The Commission has issued the enclosed Amendment Nos. 66, 62 and 38 to Facility License Nos. DPR-33, DPR-52 and DPR-68 for the Browns Ferry Nuclear Plant, Unit Nos. 1, 2 and 3. These amendments which are in response to your applications dated June 13, 1980 (TVA BFNP TS 139) and October 16, 1980 (TVA BFNP TS 152), change the Technical Specifications to (1) revise the definitions for "Limiting Conditions for Operation" and "Operability" to be consistent with the definitions in the model technical specifications enclosed with our generic letter to you of April 10, 1980, and (2) revise the definition of "Cold Shutdown" to be consistent with the "Standard BWR Technical Specifications".

SUBJECT: Tennessee Valley Authority
Browns Ferry Nuclear Plant, Unit Nos. 1, 2 and 3

AMENDMENT TO FACILITY OPERATING LICENSE

Amendment No. 66 License No. DPR-33

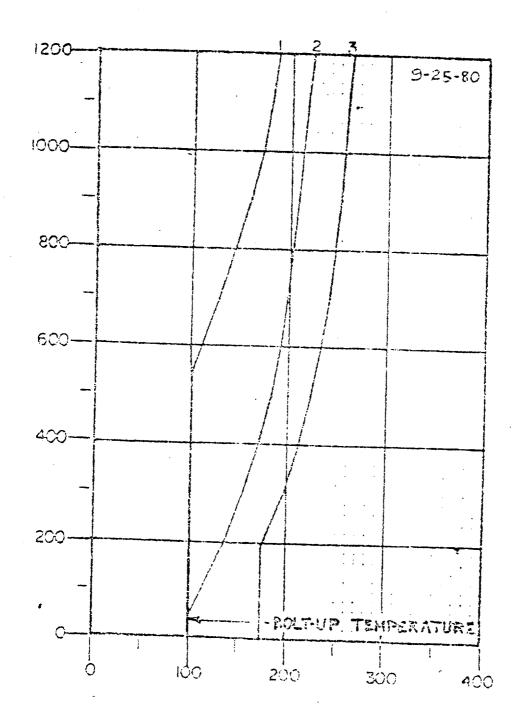
The proposed changes on page 188 of the Unit 1 and 2 Technical Specifications and on page 201 of the Unit 3 Technical Specifications is to substitute a revised Nil Ductility Temperature (NDT) operating curve. These curves specify the minimum temperature that the reactor vessel must be at for the range of primary coolant pressures. The upper portion of the curves provides an additional 20°F shift from the original curves for protection because of uncertainty of radiation damage. The lower portion of curves 2 and 3 reflect the limiting conditions for protection of the feedwater nozzles from degradation. This lower portion includes the 40°F conservatism for nuclear heatup. These proposed curves are more conservative than those in the present technical specifications and have been administratively imposed. The proposed changes are acceptable.

Curve #1
Minimum temperature
for pressure tests
such as required by
Section XI.

Curve #2 Minimum temperature for mechanical heat up or cooldown following nuclear shutdown.

Curve #3
Minimum temperature
for core operation
(criticality)
Includes additional
margin required by
10CFR50 Appendix G.
Par. IV A.2.C.

these curves are saifted 30°F to the right of the original set of curves to include a ARI of 30°F. This shift will allow these curves to used thru 4.0 EFPY.
